1 **ADDENDUM NO. 1**

4 Project Identification: Alma City Hall Remodel – Phase One  
5 Project Number: 25020  
6 Project Location: 1225 South Main Street, Alma, WI 54610  
7 Owner's Representative: Mayor Rick Champeny  
8 Architect: Lien & Peterson Architects, Inc.  
9 Supervising Professional: William Boettcher, PE  
10 Date of Addendum: February 12, 2026.

**A201**

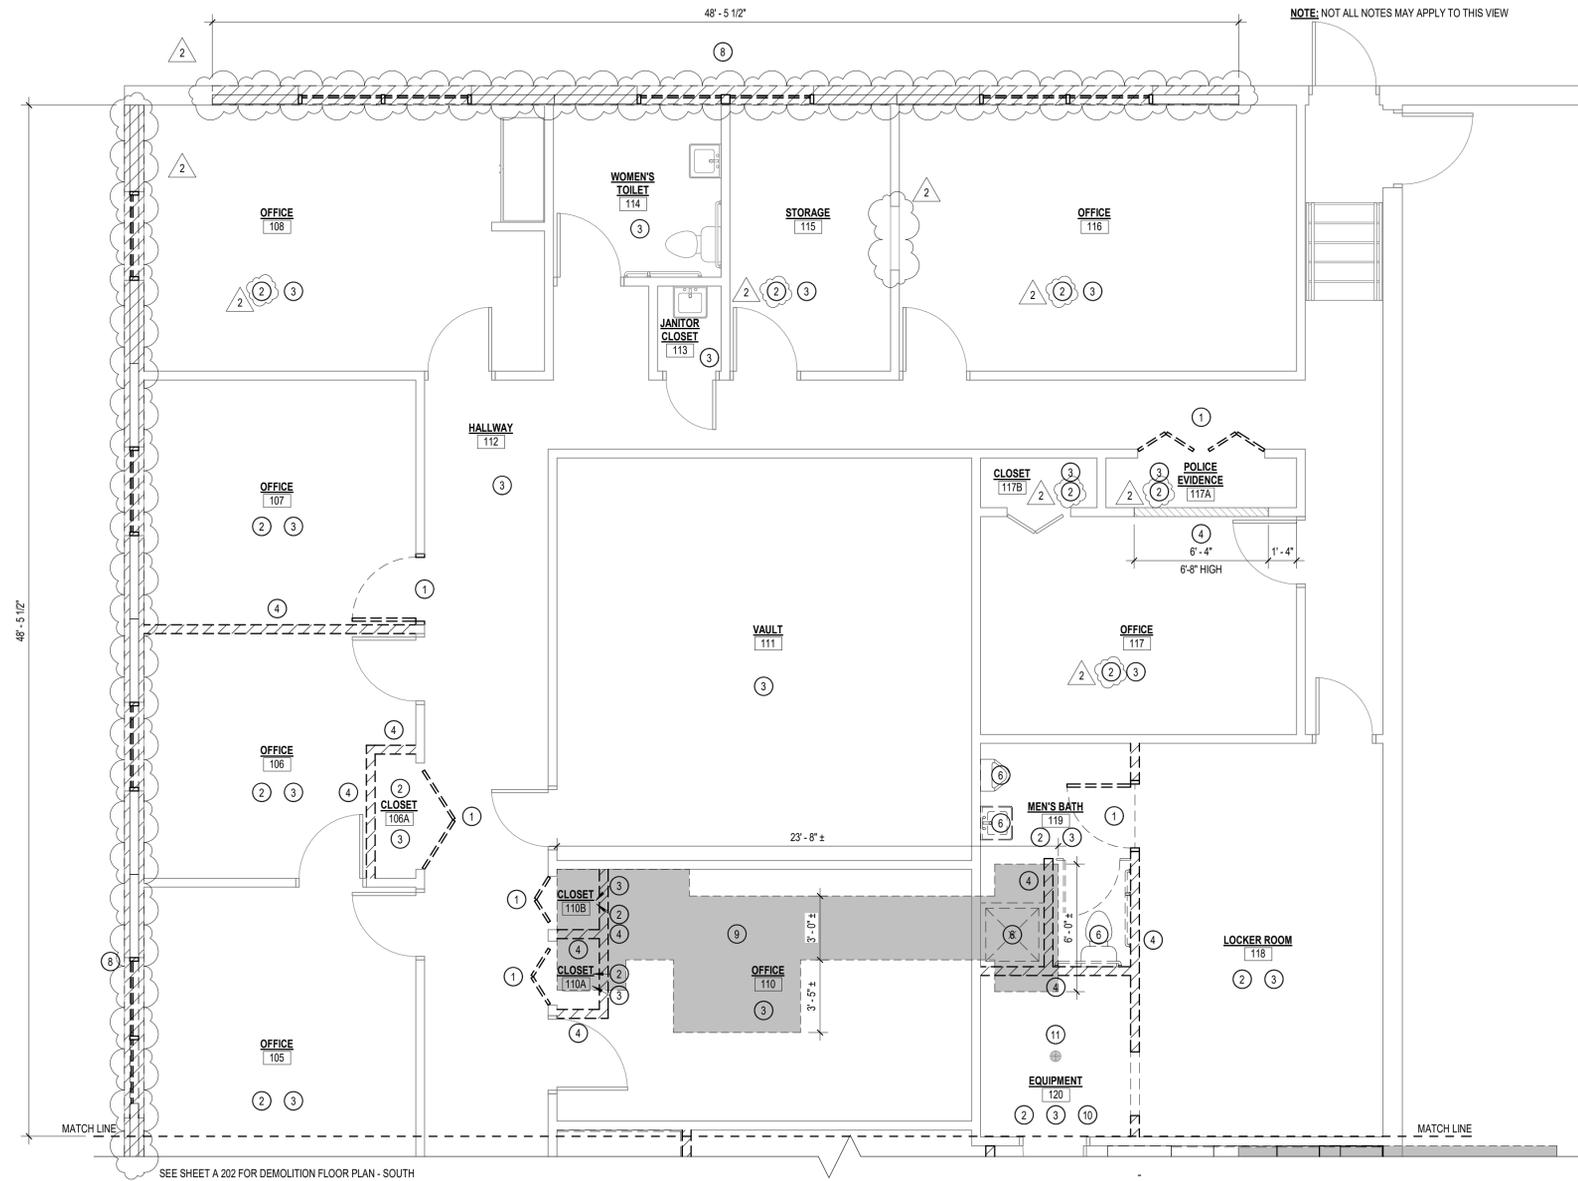
- 36 1. Plaster ceiling and insulation above to be removed in all rooms with note 3 called out on the  
37 demolition plans (sheets A201 and A202). In room 114, the lay in ceiling will also be removed.  
38 2. Terrazzo floor to remain where applicable.  
39 3. Specification Section 08 80 00 Glazing, Page 2 Lines 24-29 (Insulated Metal Panels, General) is in  
40 reference to “Replace all existing integral air transfer openings above doors with blank insulated  
41 metal panels,” on sheets A301 and A302. This Section is not meant for the Plan North and Plan  
42 West Aluminum-Framed Storefronts. There is an estimated (14) existing integral air transfer  
43 openings.  
44 4. Cross-Linked Polyethylene (PEX) piping of equivalent flow capacity to specified copper piping  
45 may be used for water distribution.  
46 5. The intention of Specification Section 07 53 23 Ethylene-Propylene-Diene-Monomer (EPDM)

31 Floor Plan: Storefront has been revised to more accurately reflect existing conditions. Added removal  
32 of floor finish and base note where applicable to reflect room finish schedule updates.  
33 Sheet A203 – Phase 1 – Demolition Roof Plan, (reissued).  
34 Roof Plan: Roof plan has been revised to more accurately reflect existing conditions. Existing roof  
35 drain note revised to coordinate with revised plumbing plans.  
36 Sheet A301 – Phase 1 – North - Remodel Floor Plan, (reissued).  
37 Floor Plan: Infill existing opening in wall between rooms 115 and 116. Storefronts have been revised  
38 to more accurately reflect existing conditions. Added installation of floor finish and base note where  
39 applicable to reflect room finish schedule updates.  
40 Sheet A302 – Phase 1 – South - Remodel Floor Plan, Enlarged Plan, (reissued).  
41 Floor Plan: Storefront has been revised to more accurately reflect existing conditions. Added

**4 PHASE 1 - WINDOW TYPES**  
1/4" = 1'-0"

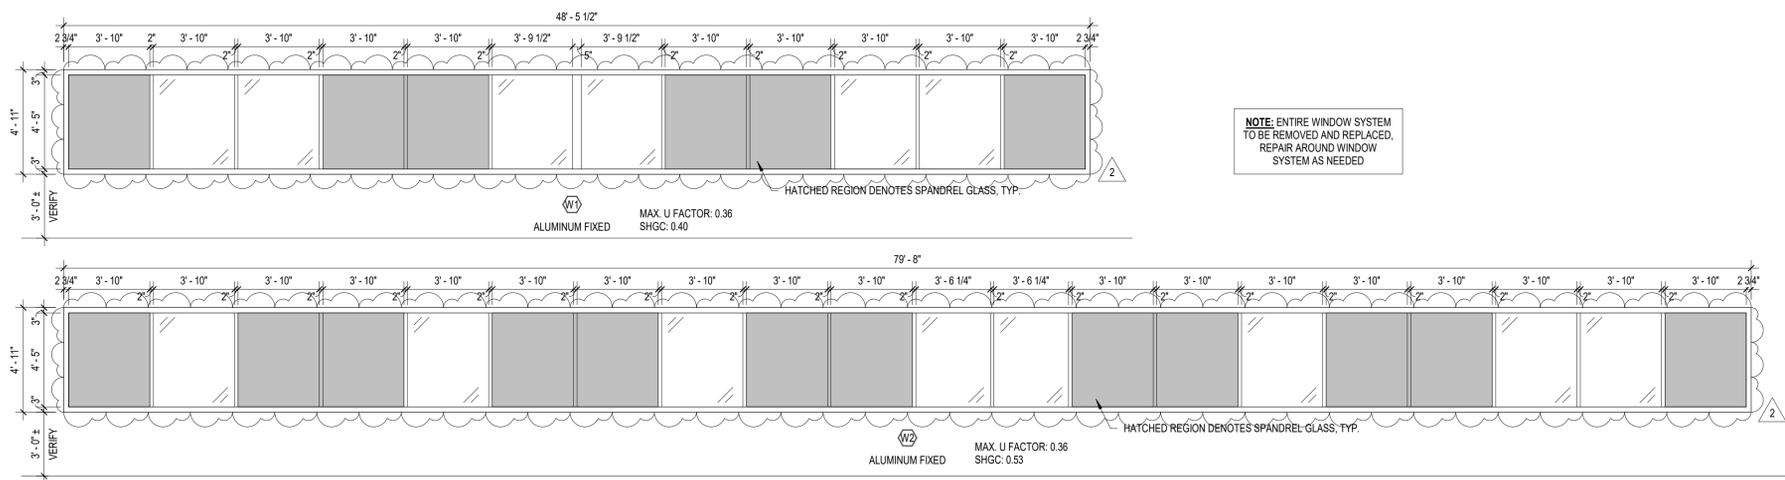
- 1 Detail 4 Window Types: Storefronts have been revised to more accurately reflect existing conditions.
- 2 These windows are to be constructed from storefront material with expansion jambs as necessary.

**A401**

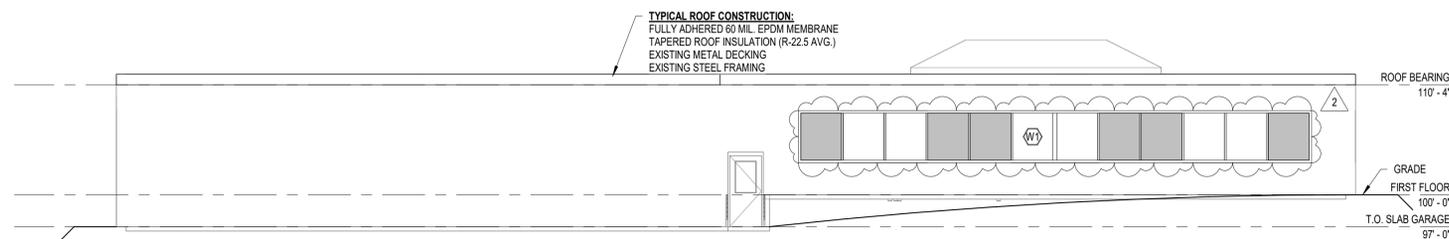
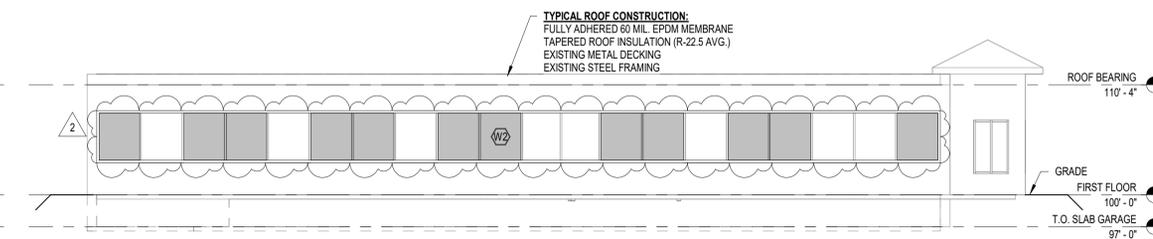
- 3 Sheet A401 – Phase 1 – Exterior and Interior Elevations, (reissued).
- 4 Elevations 1-2: Plan West and Plan North Elevation Storefronts have been revised to more accurately

- 5 reflect existing conditions.
- 6 Sheet A501 – Phase 1 – Door and Window Details, (reissued).
- 7 Details 1-3: Details have been revised to reflect use of storefront in lieu of aluminum framed windows.

**3 ALUM. STOREFRONT HEAD**  
3" = 1'-0"

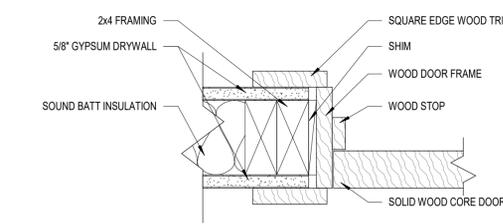
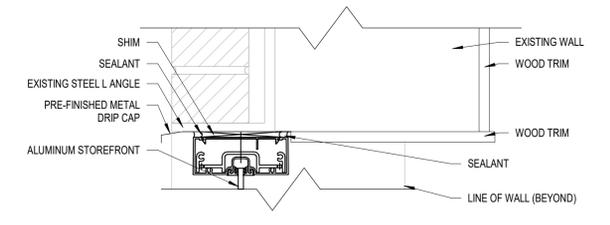
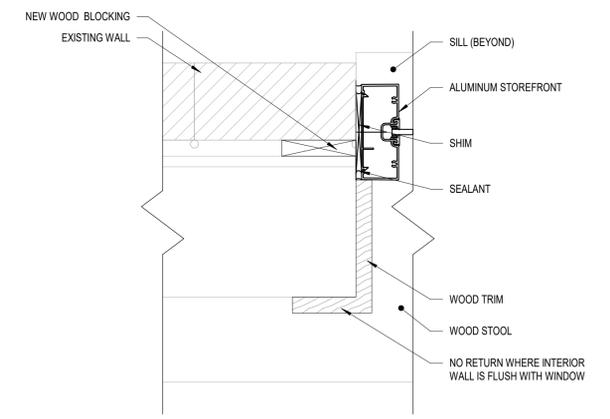
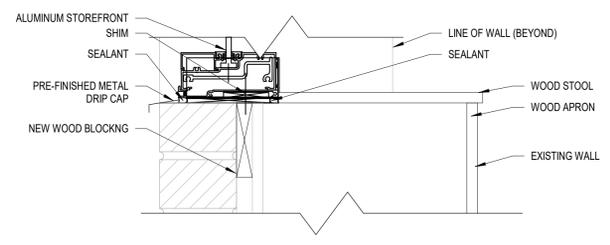
- 8 Stool depth has been adjusted to 11” to more accurately reflect existing conditions.
- 9 Sheet A701 – Phase 1 – Reflected Ceiling Plan, (reissued).
- 10 Keyed Reflected Ceiling Plan Note 1: Hold down clips only required in vestibule.

**A701**

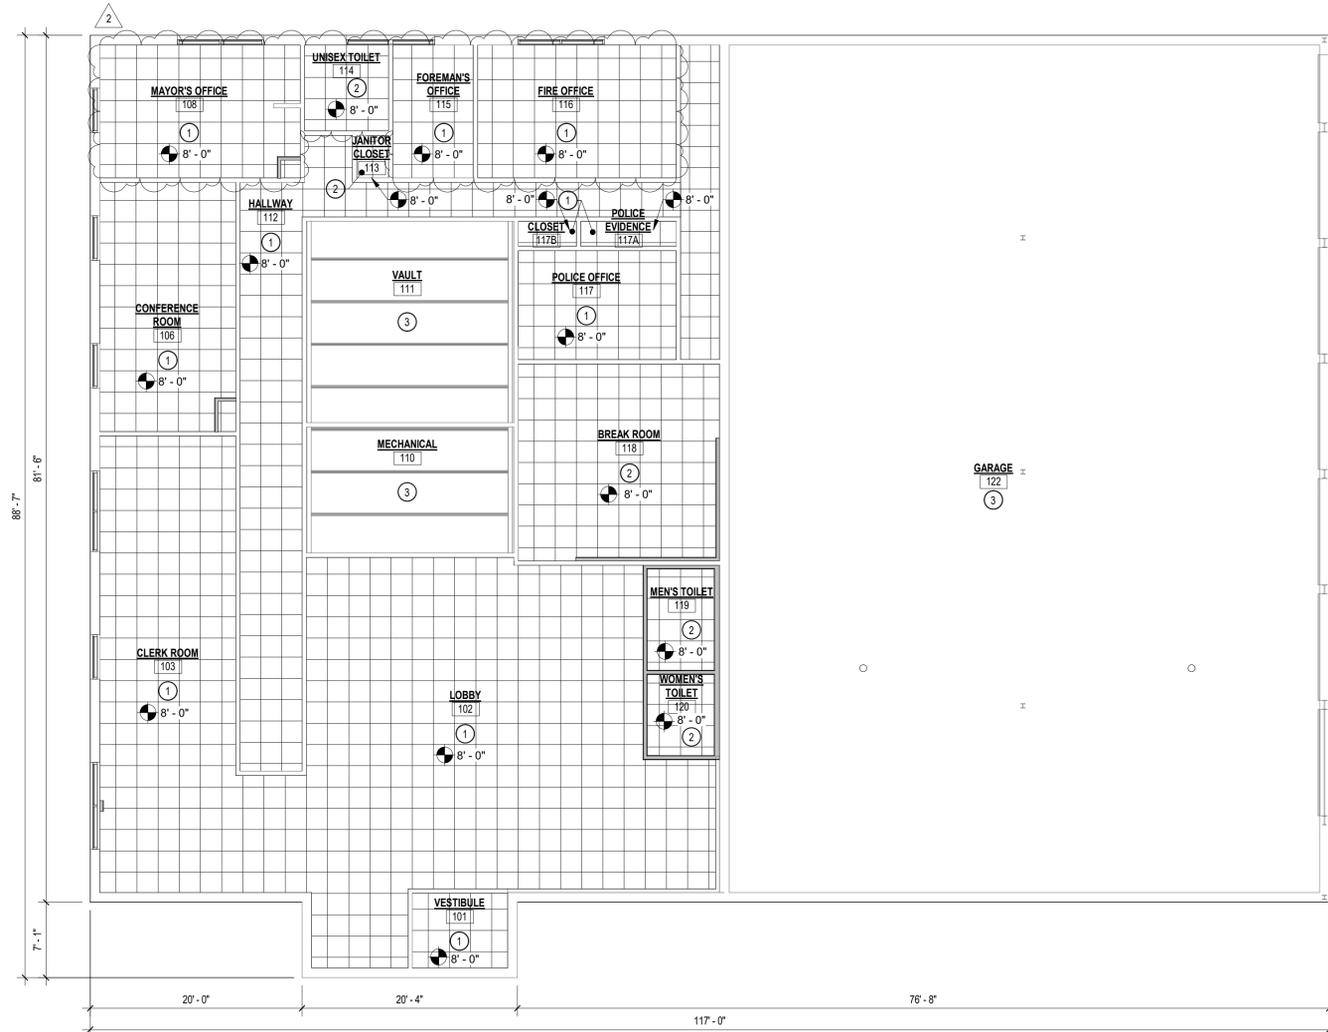
- 11 Reflected Ceiling Plan: Reflected ceiling plans in Room 108, 114, 115, and 116 revised based upon
- 12 existing conditions of Plan West storefront.

**PLUMBING DEMOLITION FLOOR PLAN**

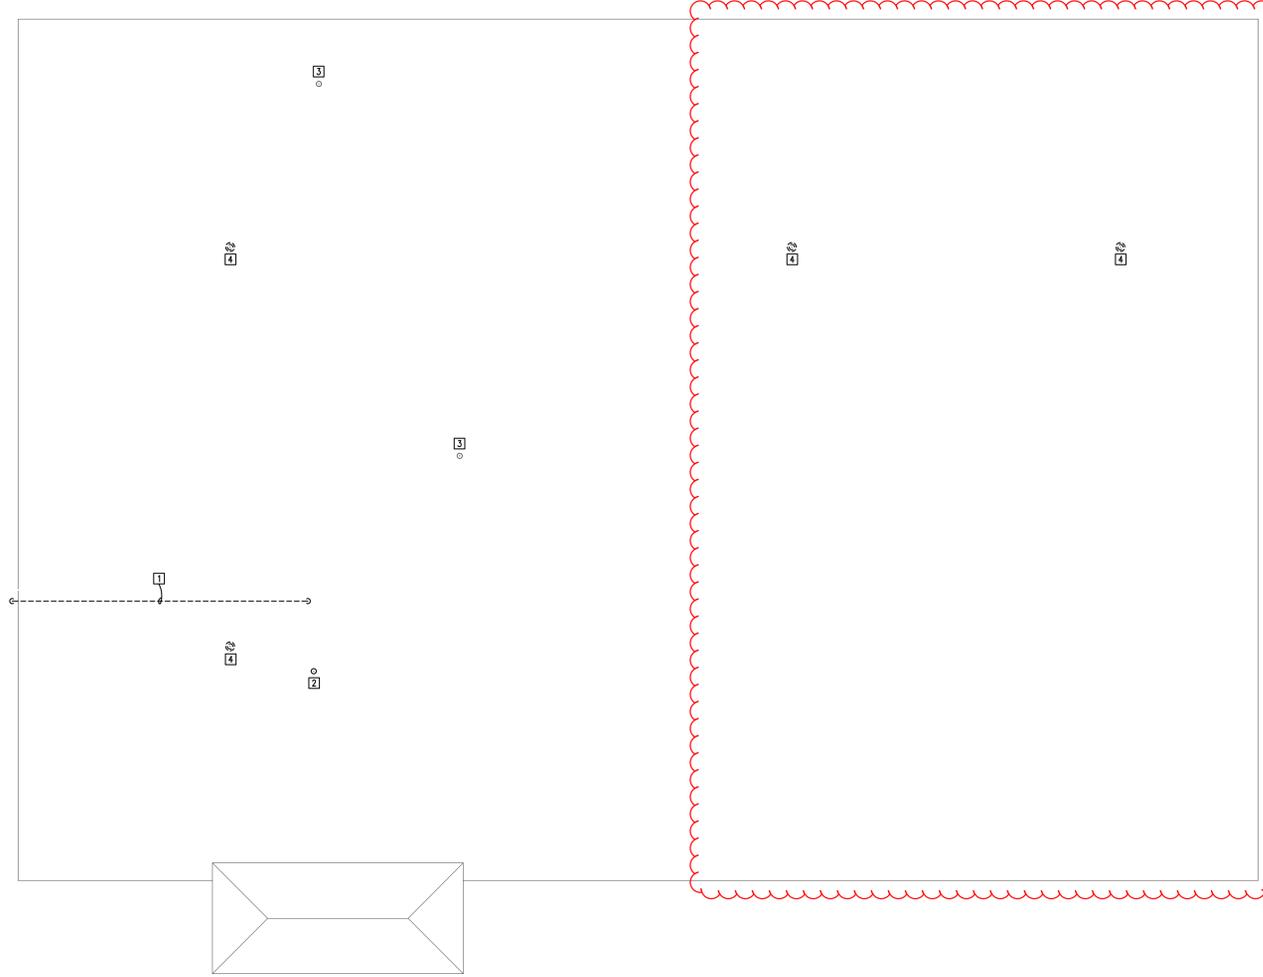
- 15 Sheet P101 – Plumbing Demolition Floor Plans, (reissued).
- 16 Plumbing Demolition Notes: Note 17 added; Existing roof drain to be disconnected and removed

- 17 during roof demolition. Rain Leader to be reconnected during new construction phase of project.
- 18 Plumbing Floor Plan, (demolition above floor): Floor plan has been revised to more accurately reflect

**P102**

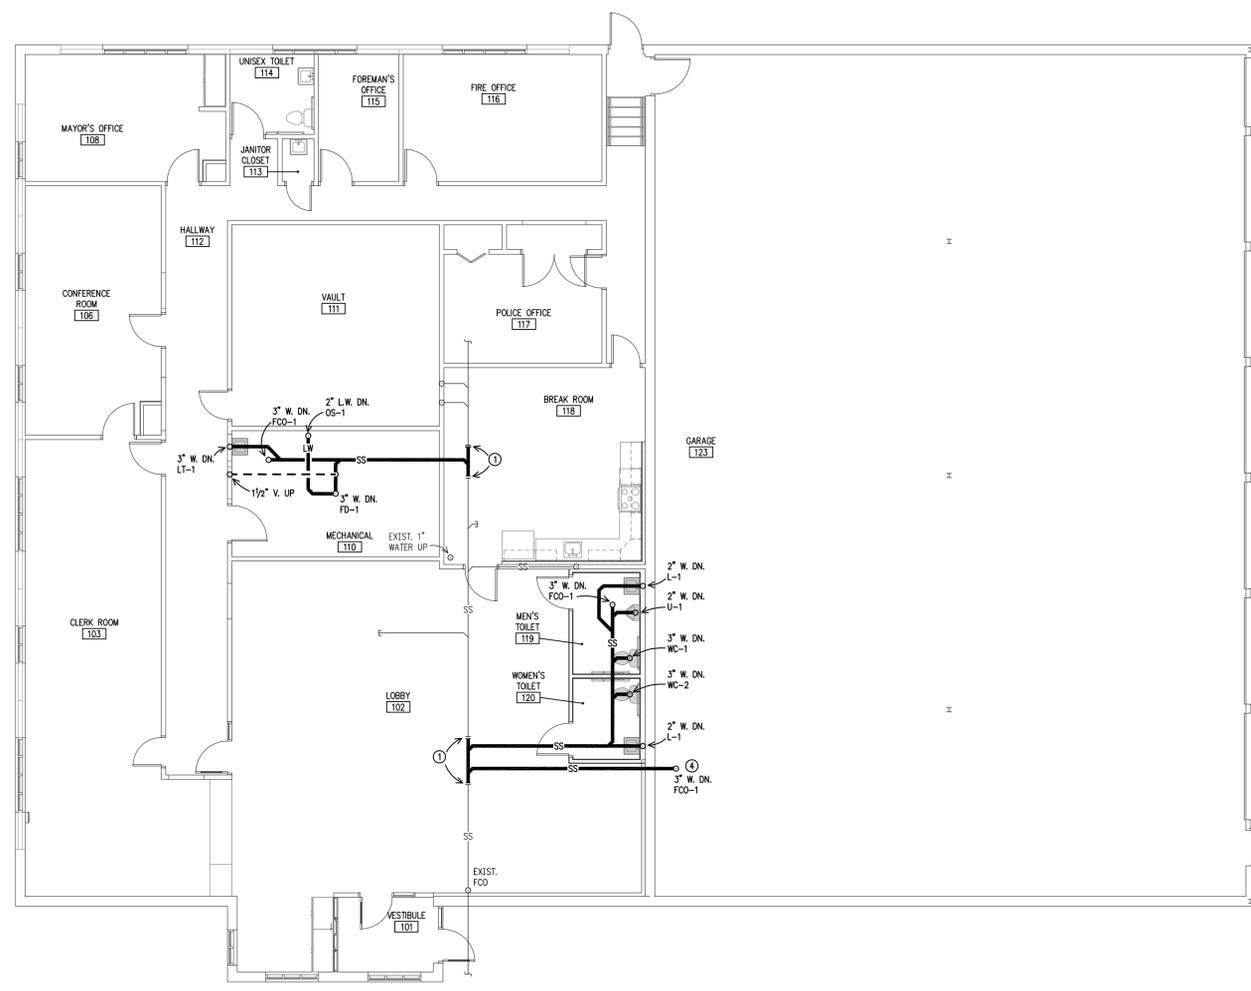
- 19 existing conditions.
- 20 Sheet P102 – Plumbing Demolition Roof Plan, (reissued).
- 21 Plumbing Demolition Notes: Note 4 added; Existing roof drain to be removed during roof demolition.

- 22 Storm piping in ceiling space and exterior downspouts to remain for reconnection during remodel
- 23 phase of project.
- 24 Plumbing Roof Plan, (demolition): Roof plan has been revised to more accurately reflect existing
